## Access Compliance Report Public Rights-of-Way (Curb Ramps)

Intersection ID: 10033044Main Street: NOLLEY\_CTCross Street: N/ALocation:NADA ID: 2BDC8FF0C0F9Ramp Type: PerpInitial Pass/Fail: FailOverall Compliance: NoSeverity Score: 22.5

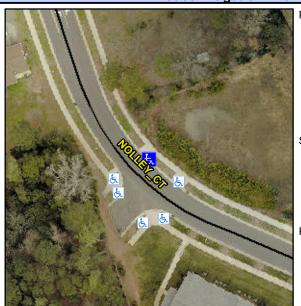
R304.5.1, R304.2.2

Remove & Replace Entire Ramp.
